UNITED STATES PATENT AND TRADEMARK OFFICE

APPLICATION NO.	FILING DATE	FIRST NAMED INVENTOR	ATTORNEY DOCKET NO.	CONFIRMATION NO.
10/692,580	10/24/2003	Boris S. Jacobson	RTN-183AUS	9035
33164 7590 12/29/2008 RAYTHEON COMPANY C/O DALY, CROWLEY, MOFFORD & DURKEE, LLP 354A TURNPIKE STREET SUITE 301A CANTON, MA 02021			EXAMINER CAVALLARI, DANIEL J	
			ART UNIT 2836	PAPER NUMBER
			NOTIFICATION DATE 12/29/2008	DELIVERY MODE ELECTRONIC

Office Action Summary

DETAILED ACTION

Figure 2

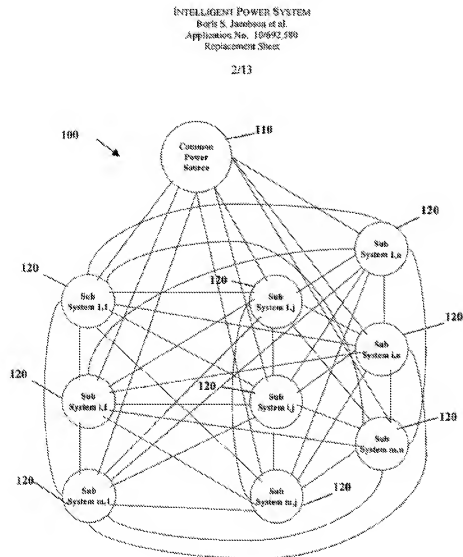
Applicant argues "As FIG.2 clearly shows, there is only a single interconnect between any two subsystem components and between a subsystem component and the common source." It is arguable whether this is clearly shown, see Figure 2 below. Figure 2 appears to show only a single connection between subsystems and between subsystems and the common power source

but the specification and other figures teach that this is not the case. In fact, each connections line drawn in figure 2 is representative of multiple connections.

The specification states “**Each line** between subsystem 120 in Figure 2 represents **multiple power and signal connections between the subsystems 120.**” (see figure 2 above). So, although figure 2 may clearly show a single interconnection between any two subsystems,

the specification clearly states that each of those lines comprises multiple connections. It appears that figure 5 of applicant's invention more clearly shows the connections between the subsystems (see figure 5 below).

Figure 5

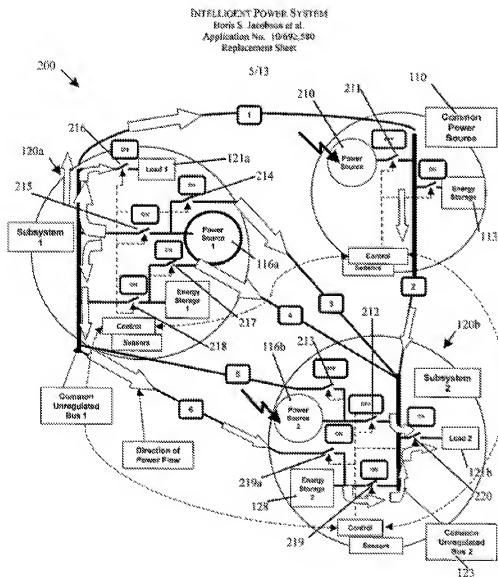
Figure 5 above shows the connection of subsystems (120a, 120b) and four power connections between 120a and 120b (see connections marked by REF# 3, 4, 5, and 6 in Figure 5 above).

Figure 5

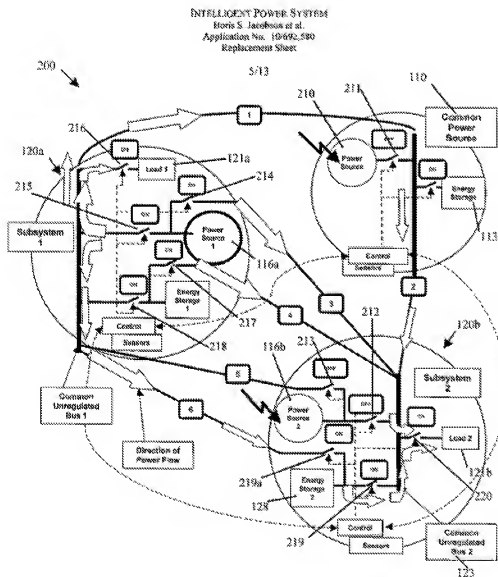
In addition to the above notes in italics, the equation itself " $k \cdot [(k-1)/2]$ " does not provide the correct number of interconnections. Figure 5 (see below) show two subsystems 120a and 120b. Therefore, according to applicant's equation, the number of interconnections is equal to $2 \cdot [(2-1)/2] = 1$ (noting that mathematically, this is readily understood by those of skill in the art). However, Figure 5 below shows two subsystems 120a, 120b and 4 interconnections (labeled 3, 4, 5, and 6). Furthermore, applicant stated that "As FIG.2 clearly shows, there is only a single

interconnect between any two subsystem components and between a subsystem component and the common power source" making it unclear why an equation to determine the maximum number of interconnections is needed.

Therefore, the claim will be examined as best understood (as shown in figure 5) wherein "k" is considered a separate and discrete variable upon each recitation in the claim.
